Final Environmental Impact Statement

SKI INCLINE
Incline Village, Nevada

SKI INCLINE
FINAL ENVIRONMENTAL IMPACT STATEMENT
RESPONSE TO PUBLIC COMMENT

Issued February 2, 1987

B. Ski slopes and hillsides east of the main lodge

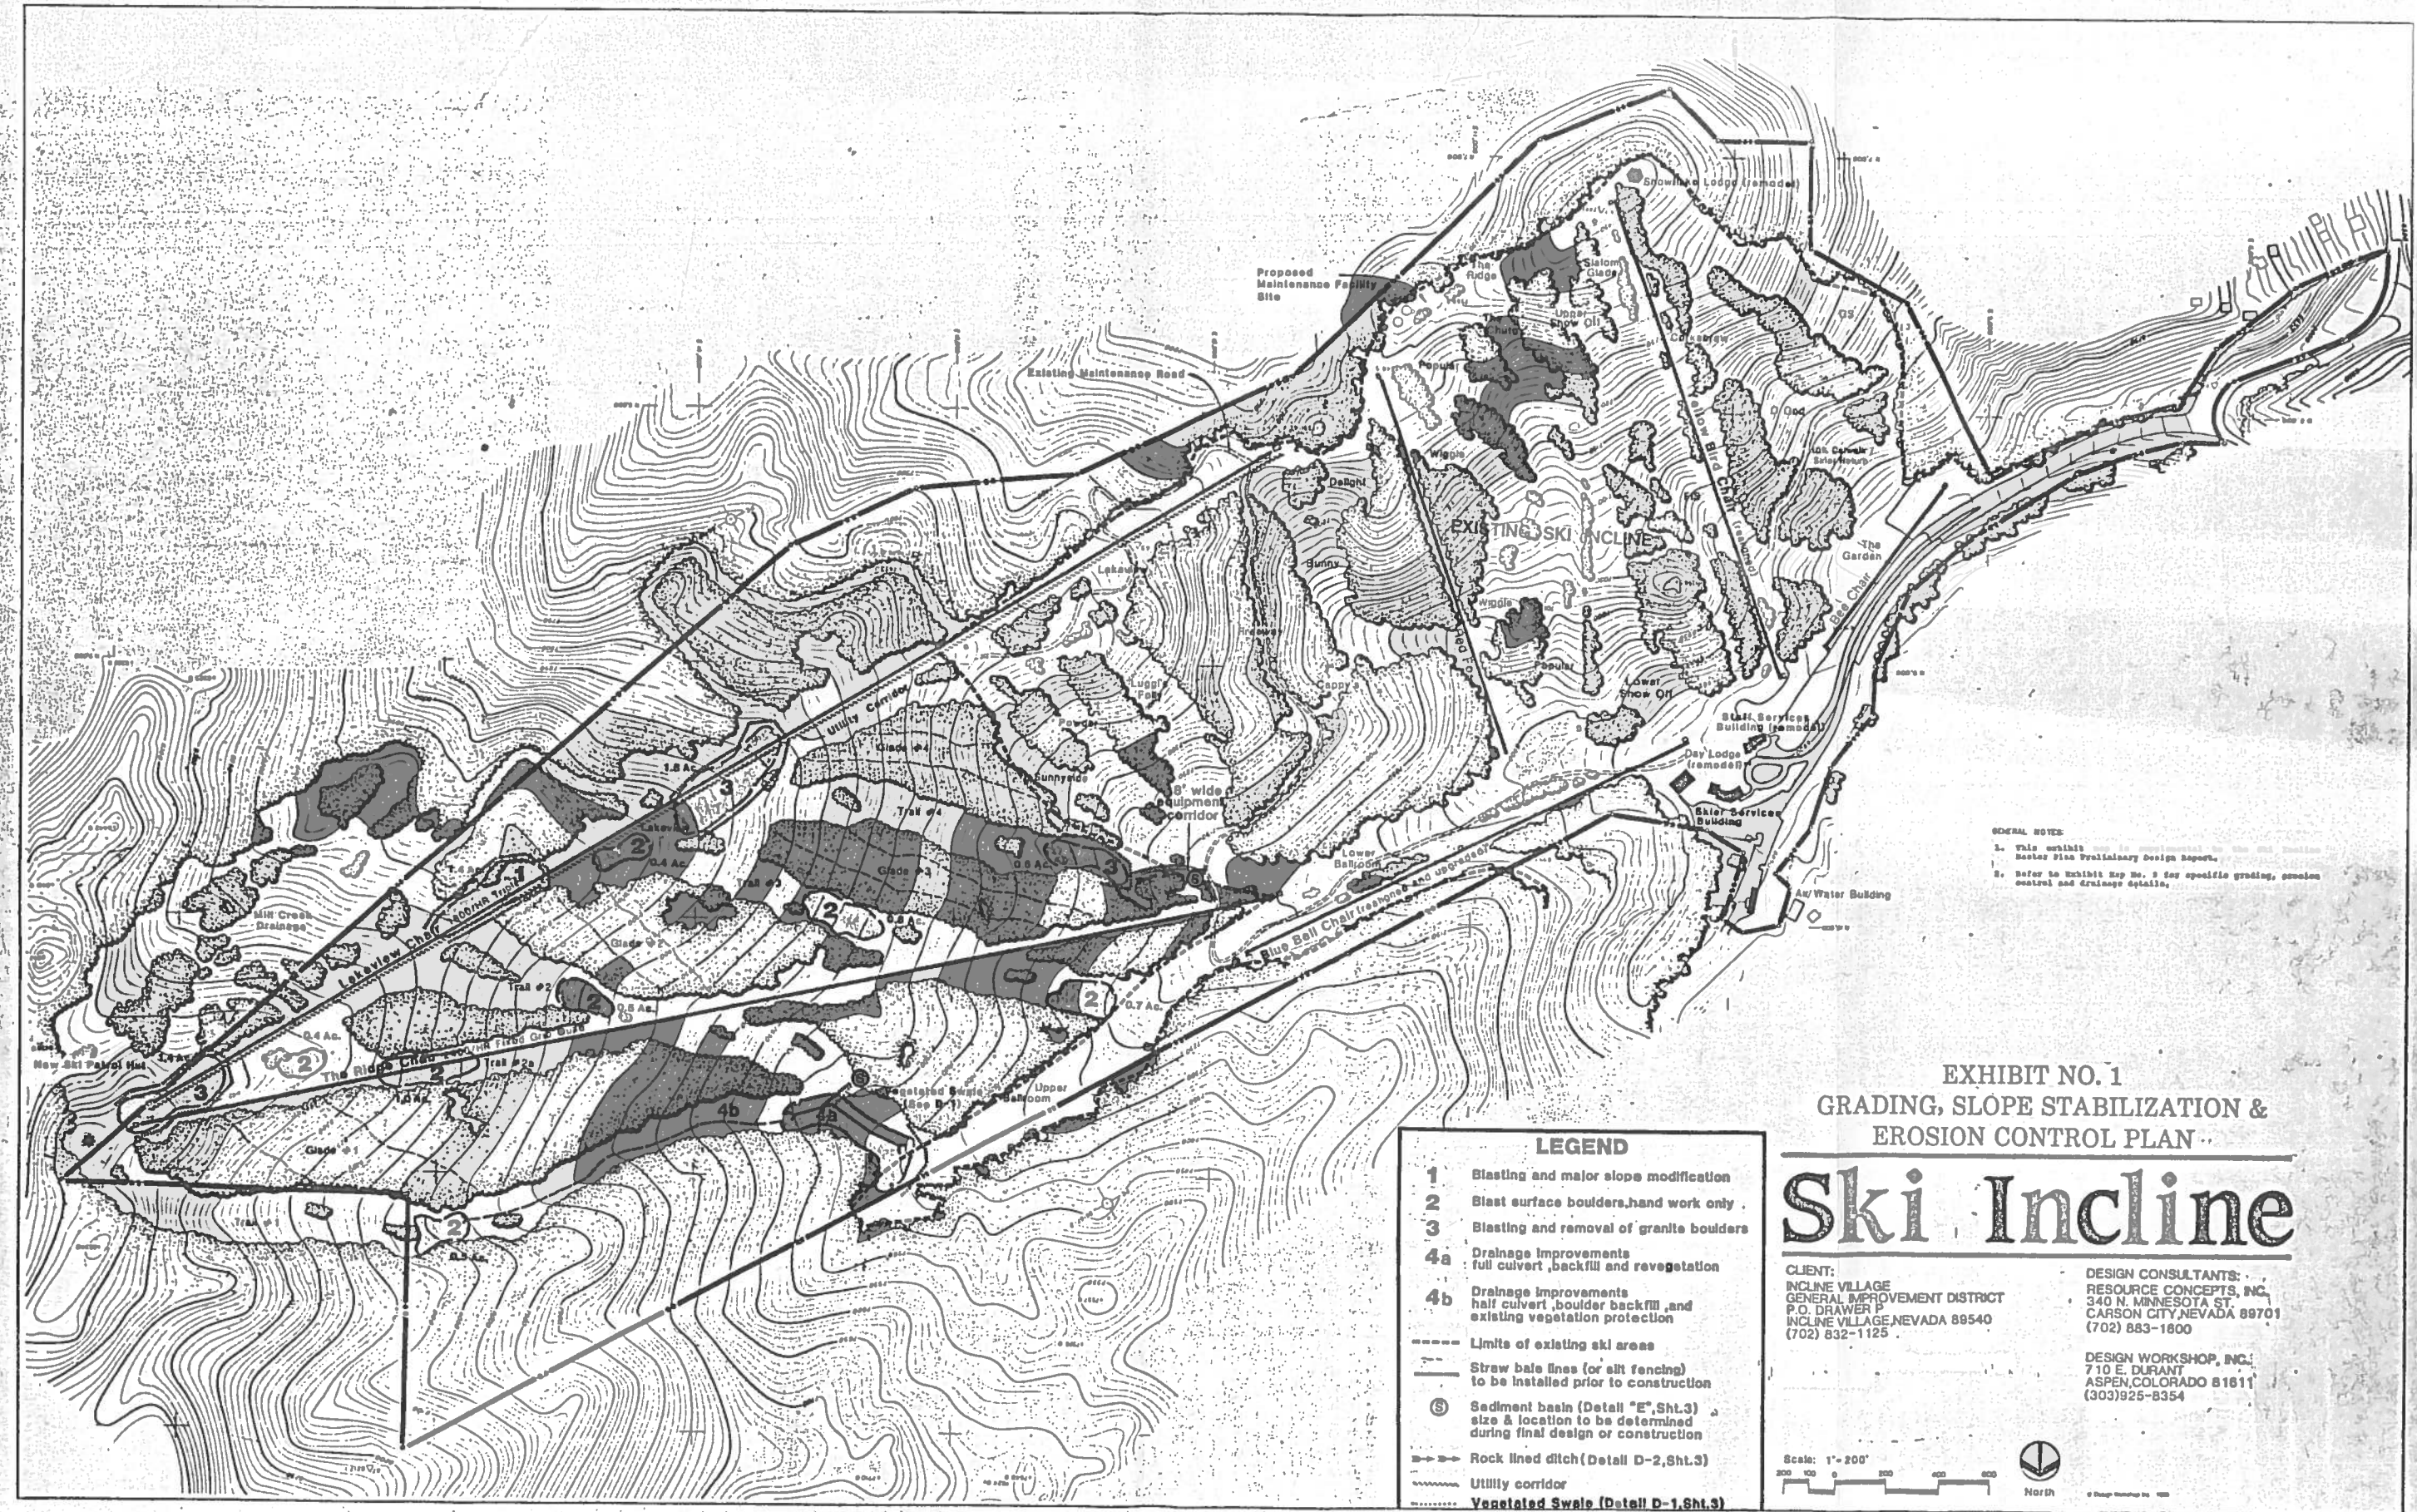
'These slopes have been modified for skiing in a way that is sensitive to the natural forms and vegetation. The resulting ski slopes are much more visually appealing than those of other ski areas in the basin. (How? Most of Heavenly Valley and Homewood can't be seen at all, but it is apparent that all of the expanded Ski Incline will be seen). These slopes with their heavy forest cover create a very scenic recreational setting and should be preserved (in what state? Developed or undeveloped?) to insure a quality recreation experience.'

EXHIBIT NO. 1
GRADING, SLOPE STABILIZATION &
EROSION CONTROL PLAN

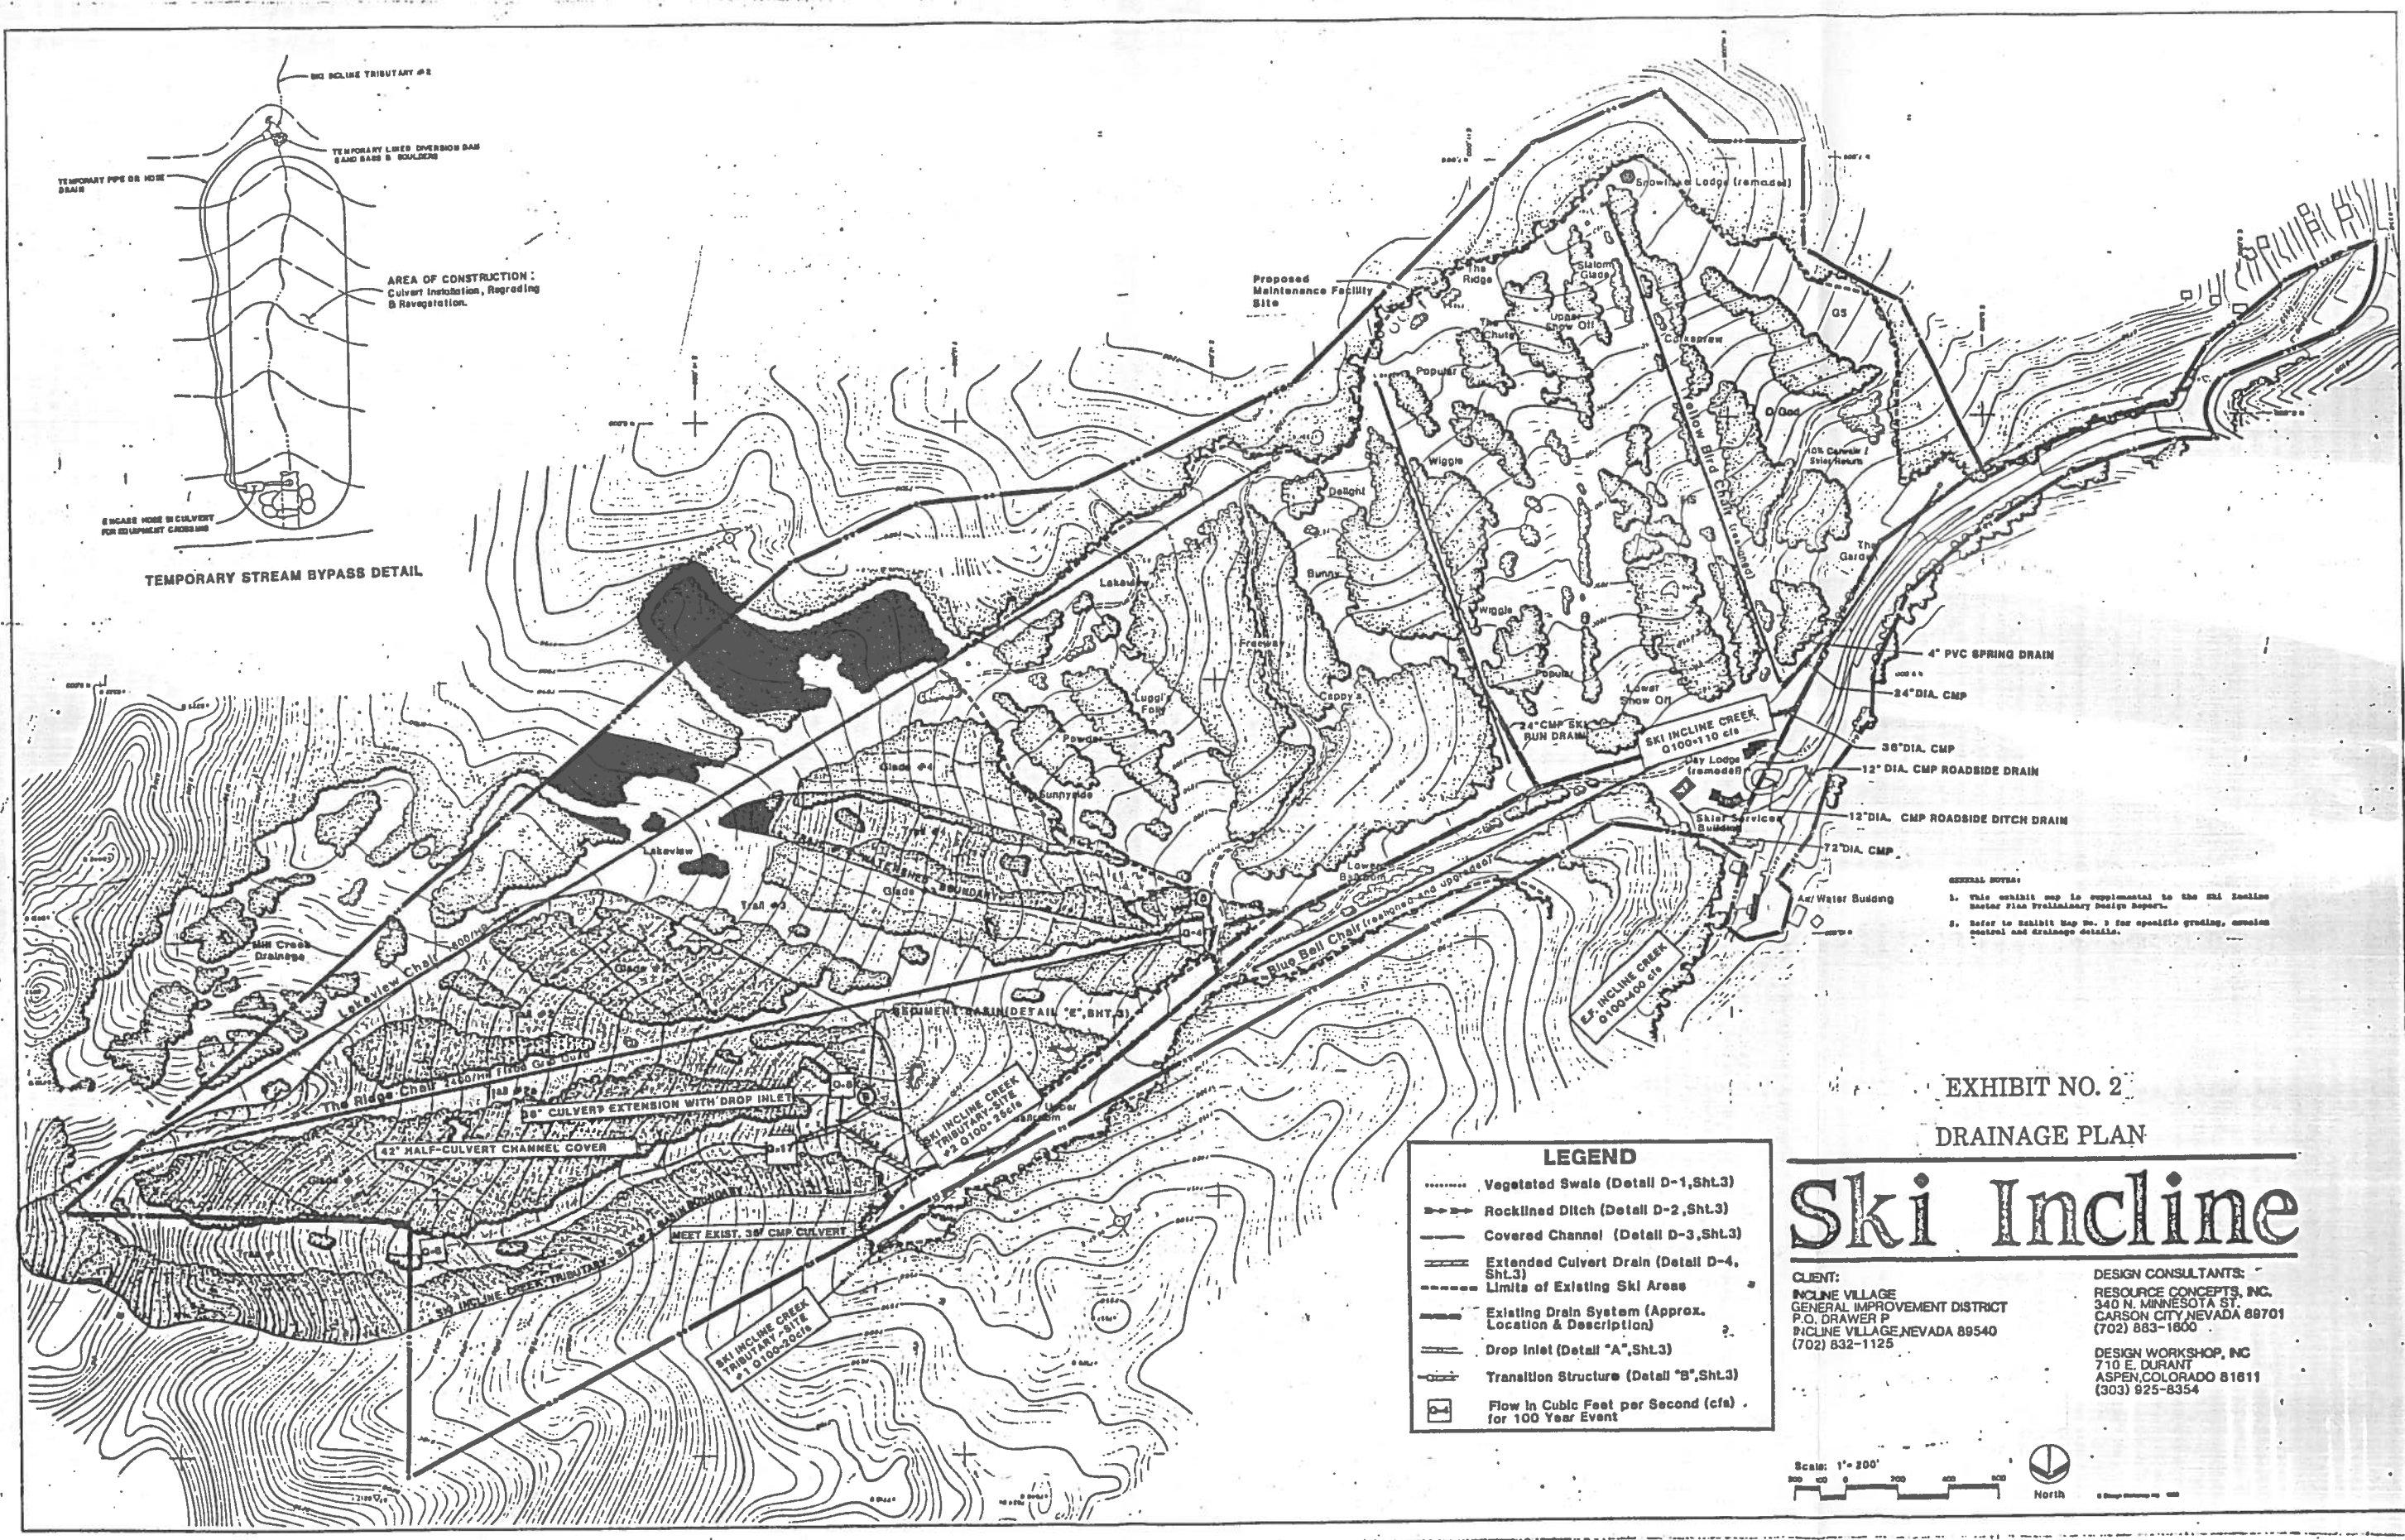
"Because the APC expressed strong concerns about the encroachment of the new ski runs on over 2 acres of existing stream environment zone (SEZ), the final EIS should expand upon the discussion of SEZ impacts, possible alternative designs which could reduce or eliminate the impacts, justifications for making the required findings which would allow public outdoor recreation encroachment in an SEZ under the TRPA Goals and Policies, and plans for mitigating impacts upon SEZ's. In particular, any specific information on offsetting SEZ restoration projects should be included, if it is available."

"It is proposed that drainage courses (erroneously referred to as 'Stream Environment Zones') be enclosed in culverts on new ski runs. The argument that this feature of the project must 'by its very nature' be located in Stream Environment Zones because ski runs generally follow the fall lines, does not seem to meet the intent of the exemption criteria in the '208' water quality plan. These criteria were intended to promote water oriented public recreation projects. Feasible alternatives to the proposed SEZ work should be considered, such as seasonal culverts or bridges which could minimize disturbance of soils and vegetation."

As disclosed in the Draft Environmental Impact Statement and described in more particulars in the Ski Incline Mountain Master Plan, approximately 1300 lineal feet of SEZ are shown for modification. Within this 1300 feet approximately 300 are shown as culvert and 1000 feet is depicted as a perforated half culvert design.

An alternative procedure was suggested by the TRPA APC which will be incorporated in the plan for construction. This suggestion calls for the seasonal removal of the half culvert section. That is, on bare ground conditions in the spring, these half culverts could be removed and stored and placed back in the stream in the fall of the year in anticipation of the ski season. It would allow for a visually complete natural stream channel and would remove any potential disruption to the natural hydrologic functions of this drainage. Another possibility exists for treatment of the second and lower portion of the drainage which would involve the slight relocation of the channel to remove surface water to the side of the projected trail route with no culvert. This alternative has been considered and it is the judgment of the professional hydrologist of the project that this approach would be equal to the proposed culvert in the existing channel in terms of environmental disruption; however, both alternatives will be discussed at the project permit stage.

- c. IVGID will restore a SEZ in the amount of 1.5 times the SEZ disturbed (permanent full culvert) as a result of the implementation of the proposed plan. This replacement will occur as a restoration of a culverted stream under the Upper Ballroom trail. The restoration shall be conducted during construction of the project. The restoration site and design shall meet with TRPA approval.
